Subject: Duke Energy Carolinas, LLC.
William States Lee III Nuclear Station - Docket Nos. 52-018 and 52-019
AP1000 Combined License Application for the
William States Lee III Nuclear Station Units 1 and 2
Response to Request for Additional Information
(RAI No. 1487 Revision 1)
Ltr# WLG2009.04-03

Lee Nuclear Station Response to Request for Additional Information (RAI)

RAI Letter No. 063

Reference NRC RAI Number(s): RAI 02.05.02-035

Figure 1. Lithotectonic Map Showing Seismicity and Locations of the Lee, Catawba, McGuire, and Oconee Sites.

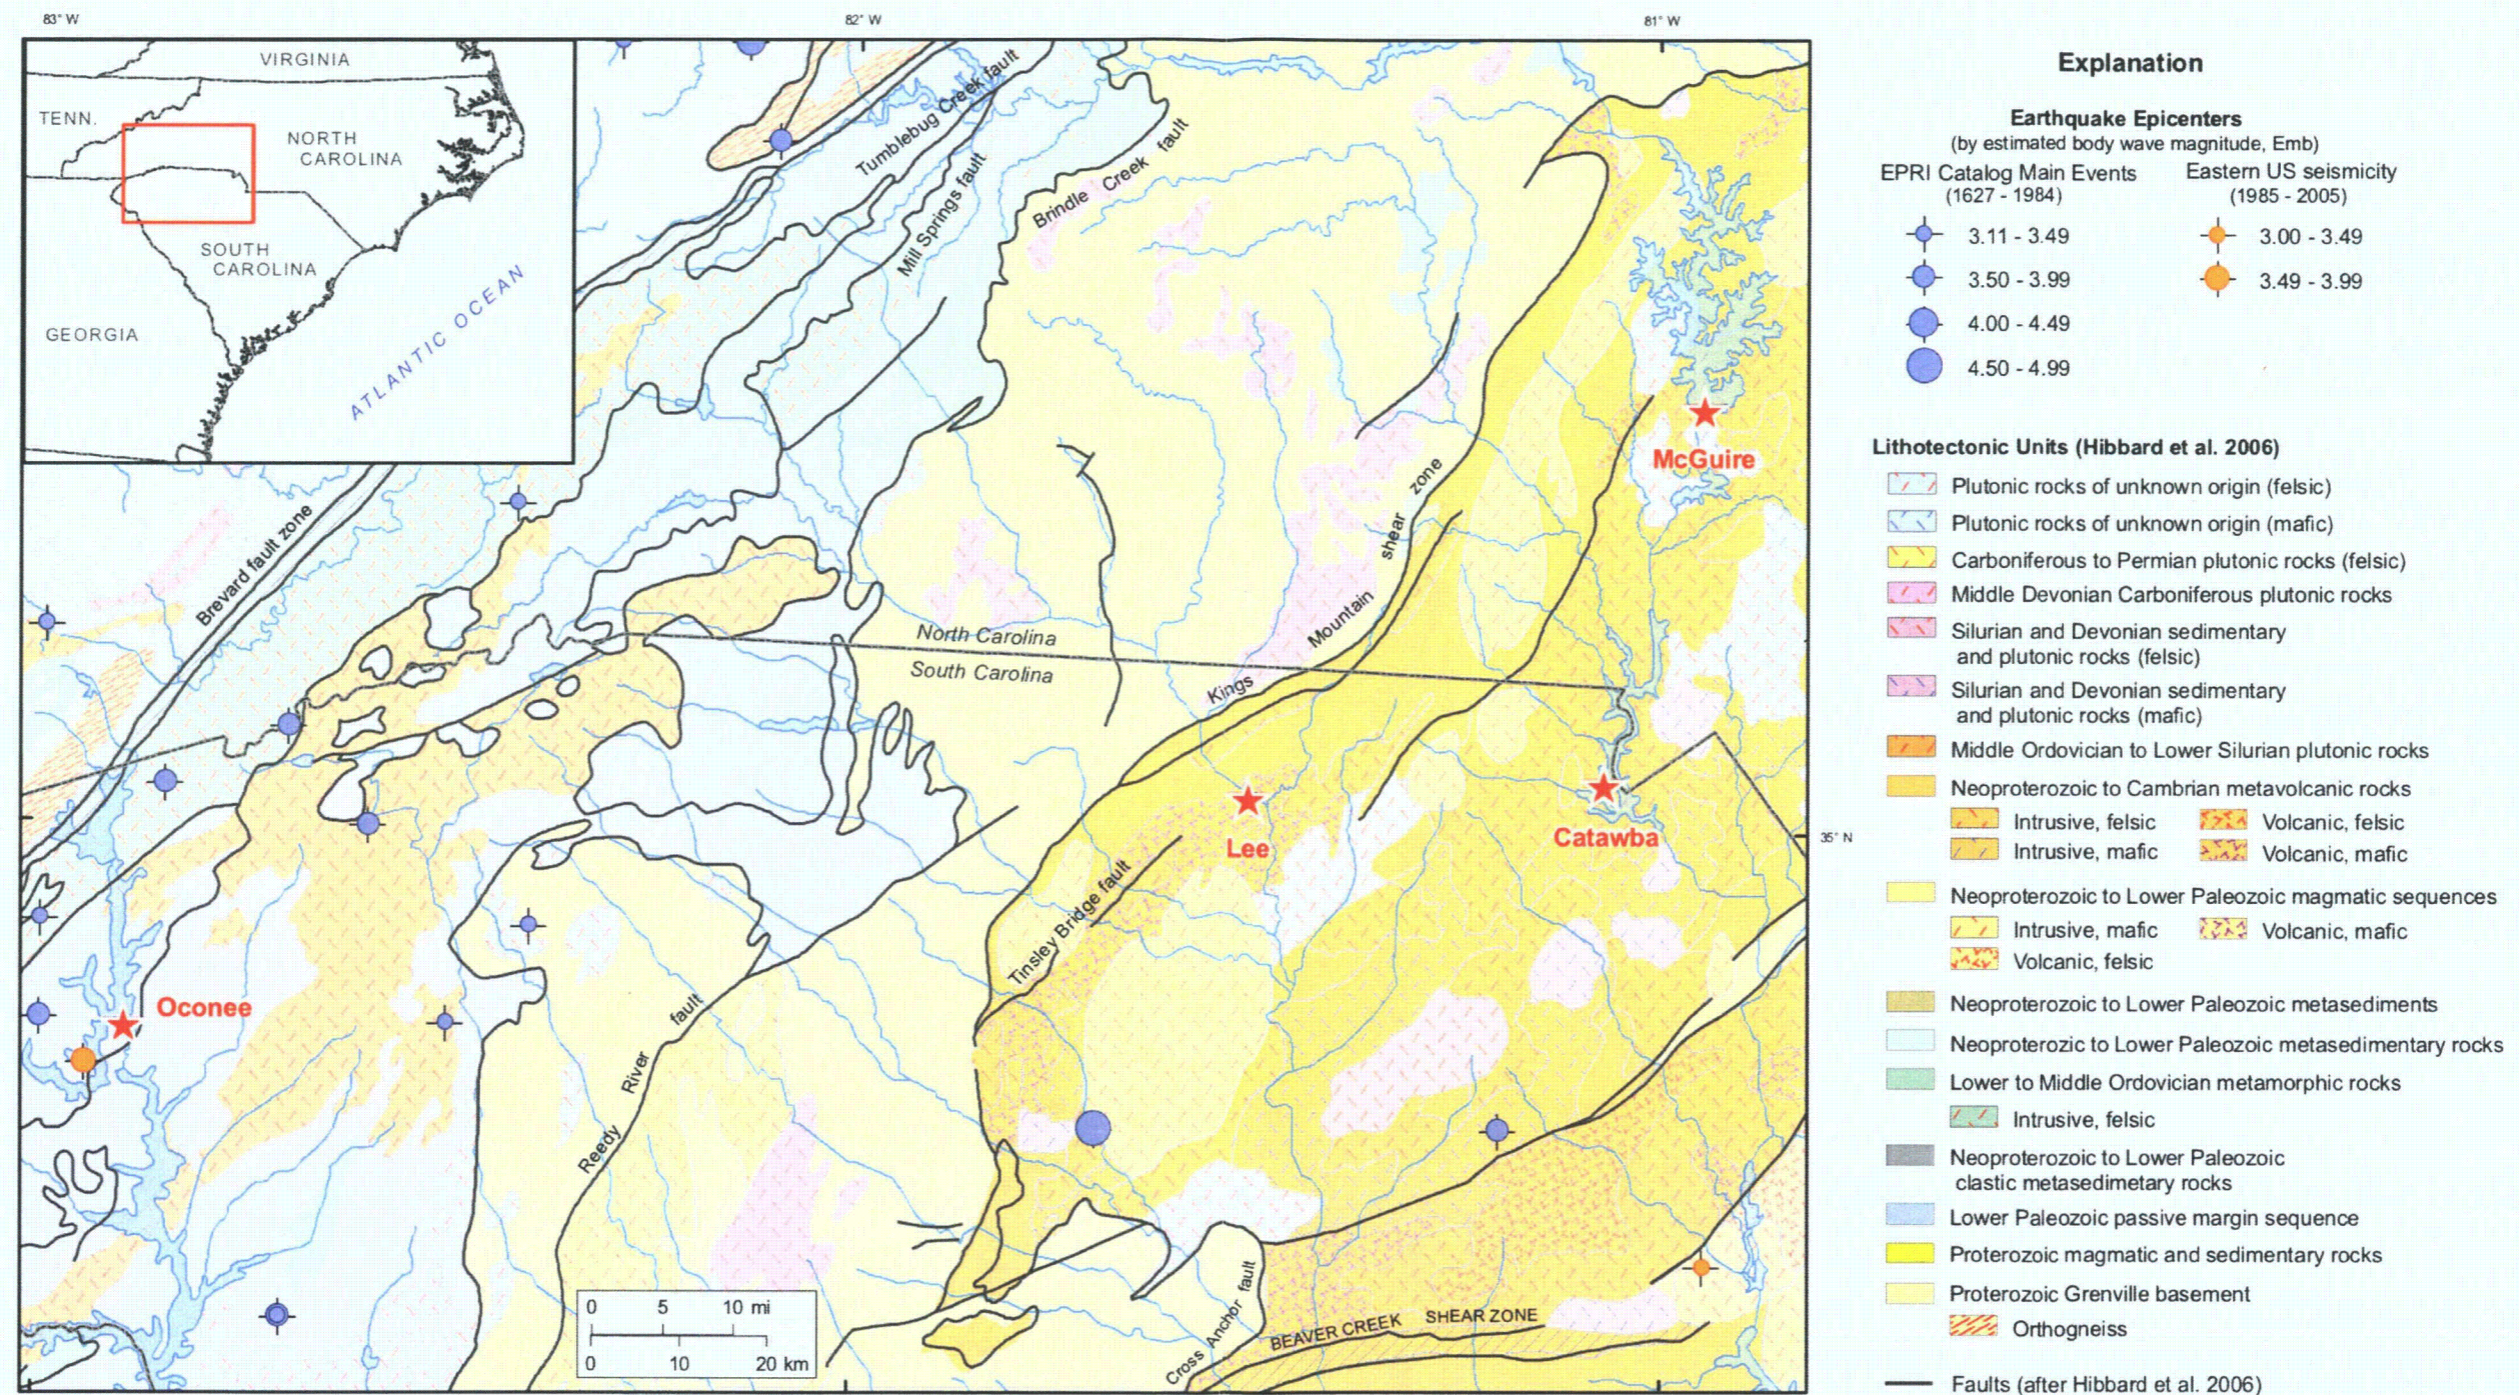
FSAR Section 2.5.2.4 (pg 2.5-115) mentions the Catawba, McGuire and Oconee sites in regard to comparing the percent difference of seismic hazard calculated for the Lee site to those other hard-rock sites in the CEUS. These comparisons are presented in FSAR Table 2.5.2-216. However, the locations of the four sites are not shown relative to each other or to regional geology and seismicity. Please provide a figure showing the relative locations of the Lee, Catawba, McGuire and Oconee sites, including generalized geology and seismicity, to accompany the information shown in Table 2.5.2-216.

Figure 1 shows the locations of the Lee, Catawba, McGuire, and Oconee sites, and includes generalized geology modified after Hibbard et al. (2006) (FSAR Reference 2.5.3-210) and earthquake epicenters from the updated seismicity catalog assembled for the Lee COLA. As shown on Figure 1, all four sites are located within metamorphosed intrusive, volcanic, or sedimentary rocks of Neoproterozoic to Cambrian age. Moreover, all four sites are located in areas of sparse seismicity.

FIGURE 2.5.2-223

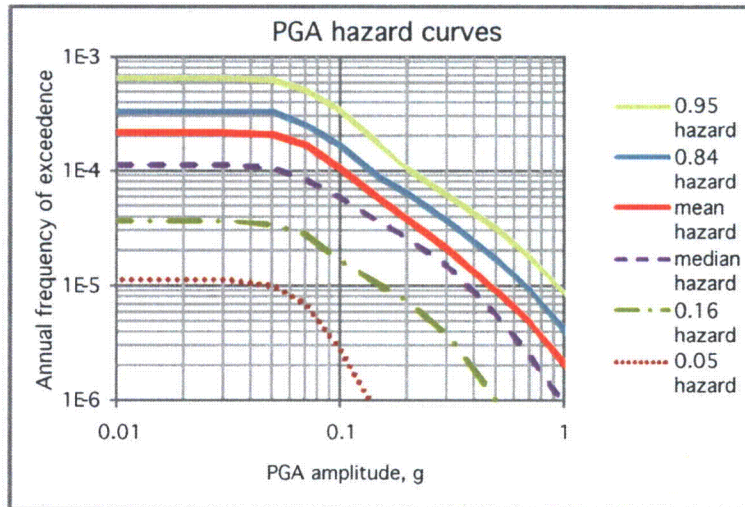
RG 1.208 states that fractile hazard curves should be reported at the 0.05, 0.16, 0.50, 0.84 and 0.95 levels. FSAR Figures 2.5.2-223 through 2.5.2-229 only show mean, median and 0.15 and 0.85 fractile hazard curves. Also, Figure 2.5.2-230 does not illustrate the rock UHRS for 10⁻⁶ annual frequencies.

Please include the suggested fractile hazard curves in Figures 2.5.2-223 through 2.5.2-229, and plot the rock UHRS for 10⁻⁶ annual frequencies in Figure 2.5.2-230.

The requested fractile hazard curves and the rock Uniform Hazard Response Spectra (UHRS) for 1E-6 annual frequency of exceedance are included in revised FSAR Figures 2.5.2-223 through 2.5.2-229, and in revised FSAR Figure 2.5.2-230, respectively. The revised figures attached to this enclosure will be incorporated into a future revision of the Final Safety Analysis Report.

FIGURE 2.5.2-228

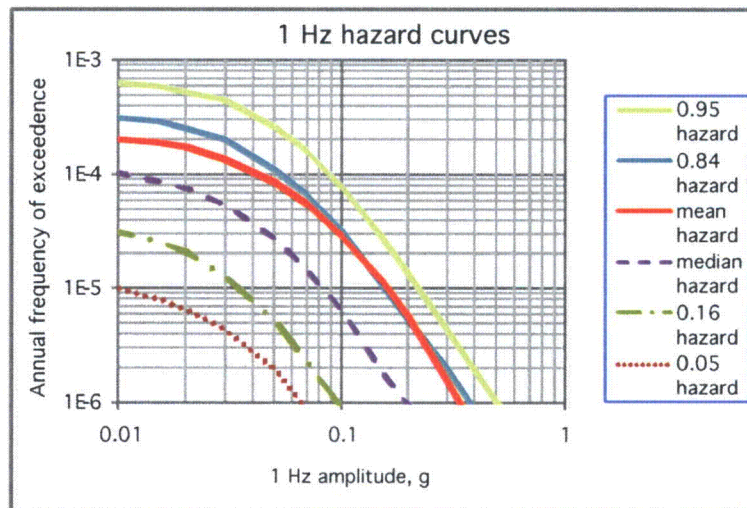
In FSAR Figure 2.5.2-228 (i.e., the 1 Hz hazard curve), the mean hazard matches the 85 percentile hazard at exceedence frequencies less than $\sim 2e-5$. In Figure 2.5.2-229 (0.5 Hz hazard curve), the mean hazard exceeds the 85% percentile hazard at exceedence frequencies less than $\sim 6e-5$. This information suggests an extremely “fat-tailed” distribution of hazard at low spectral frequencies (long periods) and higher (0.1 g) ground motions.

The mean hazard in FSAR Figures 2.5.2-228 and 2.5.2-229 is near or above the 85% hazard because the New Madrid seismic zone contributes significantly to the hazard at low spectral frequencies (1 Hz and 0.5 Hz), and because one equation from the EPRI (2004) (FSAR Reference 2.5.2-202) study dominates the hazard for large magnitudes at long distances. The New Madrid seismic zone is about 740 km from the Lee site, and produces magnitudes in the range 7 to 8, and this source contributes significantly to hazard at low spectral frequencies (see FSAR Figures 2.5.2-231, 2.5.2-233, and 2.5.2-235).

**Figure 1. Probability of $CAV > 0.16$ g-sec as a Function of Earthquake
Magnitude and PGA Level**

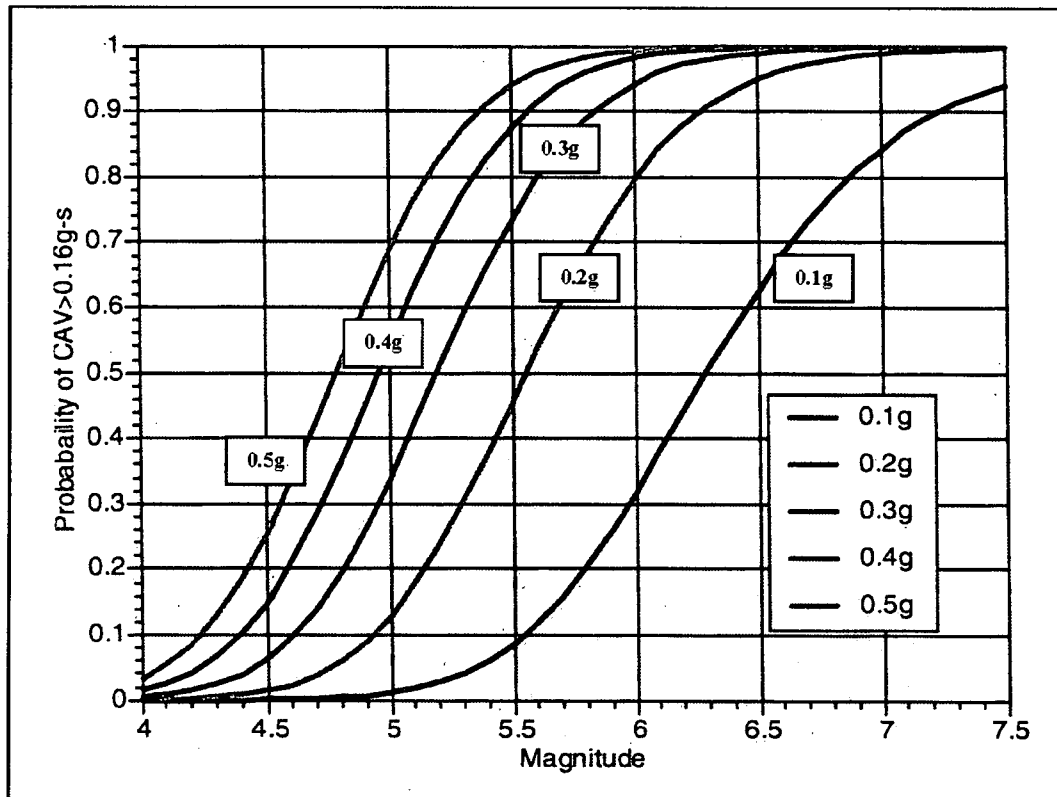
FSAR Section 2.5.2.4.4 discusses implementation of the Cumulative Absolute Velocity (CAV) model of Abrahamson and Watson-Lamrey (2005). Please provide details on how the CAV filter was implemented and how it impacts the hazard.

The Duke Energy response to RAI 02.05.02-047 (Enclosure 10 of this letter) corrects the author citation for FSAR Reference 2.5.2-250. The Cumulative Absolute Velocity (CAV) model is applied using the procedure described in Hardy et al. (2006) (FSAR Reference 2.5.2-250 as revised in Enclosure 10 of this letter), in accordance with Regulatory Guide 1.208. The CAV model accounts for the non-damageability of ground motions from small magnitude, short duration earthquakes. A CAV amplitude of 0.16 g-sec is used as a conservative threshold below which ground motions will not cause damage to engineered facilities. The relevant equation for calculating the probability of $CAV > 0.16$ g-sec is given in Equations 2-2, 2-4, 2-7, and 2-8 of Hardy et al. (2006). Equation 2-7 of Hardy et al. (2006) is plotted in the attached Figure 1, which is taken from Figure 2-34 of Hardy et al. (2006). CAV depends on the magnitude of the earthquake, on the peak ground acceleration (PGA) level, on the site conditions as represented by the average shear wave velocity in the top 30 m (V_{S30}), and on duration of the ground motion, which is estimated from the magnitude. As Figure 1 shows, as the magnitude of the earthquake increases and/or the PGA level increases, the probability of $CAV > 0.16$ g-sec increases to unity.

The CAV model was implemented in the seismic hazard calculations by calculating the probability that $CAV > 0.16$ g-sec, and by modifying the frequency of exceedance of ground motions within the hazard calculations to only include damaging ground motions (i.e., by multiplying by the probability that $CAV > 0.16$ g-sec). As indicated above, this calculation depends on the magnitude of the earthquake, on the peak ground acceleration (PGA) level, on the site conditions as represented by the average shear wave velocity in the top 30 m (V_{S30}), and on duration of the ground motion, which is estimated from the magnitude. Seismic hazard calculations for spectral accelerations other than 100 Hz (which is equivalent to PGA) are discussed in the Duke Energy response to RAI 02.05.02-047 (Enclosure 10 of this letter).

The effect of the CAV filter on seismic hazard curves is to limit the hazard at low amplitudes to an asymptotic value, which is the frequency of occurrence of damaging ground motions from earthquakes in the region. At high amplitudes, there is little effect of the CAV filter. If the CAV filter had not been applied, the hazard curves would not roll over to the horizontal asymptote but would be higher at small amplitudes. At high amplitudes there would be little to no difference in the seismic hazard curves.

Figure 1. Predicted Ground Motions for M 5.7 at 10 Hz

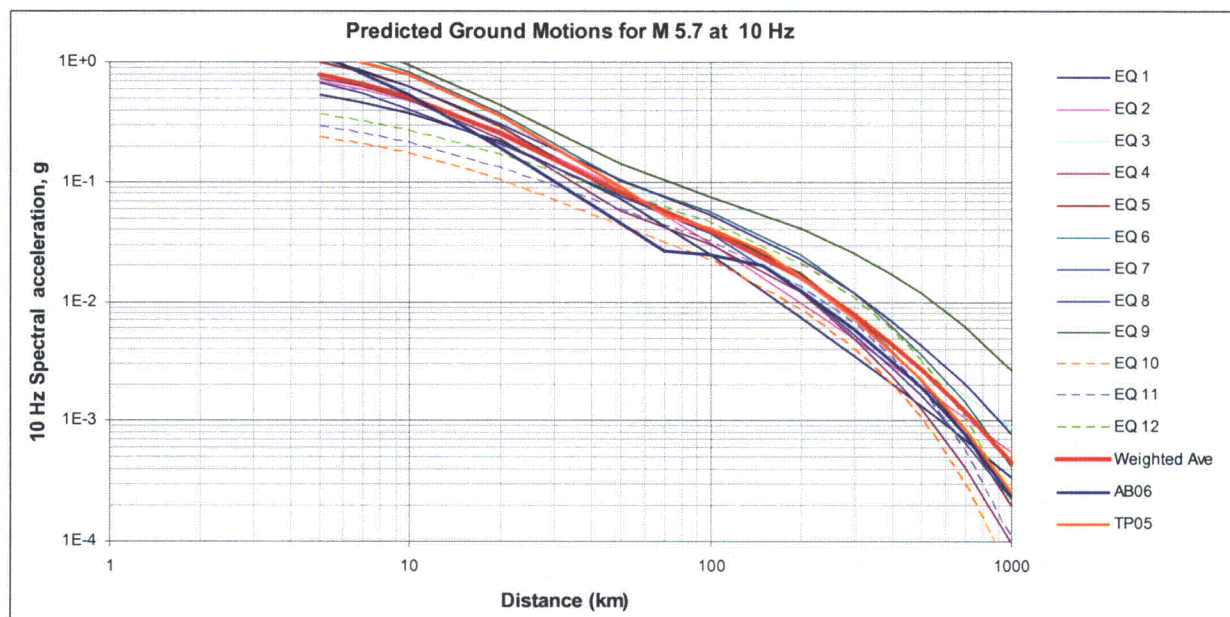
The FSAR uses the EPRI (2004) ground motion equations in the updated PSHA. Since 2004, however, two new ground motion prediction models for the CEUS have been published. These published models are "Empirical-stochastic ground-motion prediction for eastern North America", Tavakoli and Pezeshk (BSSA, 2005, v.95[6], 2283-2296); and "Earthquake groundmotion prediction equations for eastern North America", Atkinson and Boore (BSSA, 2006, v.96[6], 2181-2205).

Please describe the potential impact of these two new ground motion relations on the results of the PSHA.

The attached Figure 1 plots ground motion amplitudes for 10 Hz spectral acceleration for magnitude 5.7 ($M = 5.7$) earthquakes versus distance for the twelve equations used from EPRI (2004) (FSAR Reference 2.5.2-202), Tavakoli and Pezeshk (2005) (Reference 1), and Atkinson and Boore (2006) (Reference 2). At all distances, the range of the twelve EPRI (2004) models encompasses the ground motions predicted by the other two references, with the exception of approximately 55-85 km, where the Atkinson and Boore (2006) curve falls below the range of the EPRI (2004) models. The "Weighted Ave" curve (which is the weighted mean of the EPRI (2004) equations) generally falls between the ground motions estimated by other two references.

On the basis of the comparisons shown in Figures 1 and 2, it can be concluded that the potential impact of the Tavakoli and Pezeshk (2005) and Atkinson and Boore (2006) equations on the seismic hazard analysis would be very small, since the EPRI (2004) equations give similar ground motions over a wide range of magnitudes and distances.
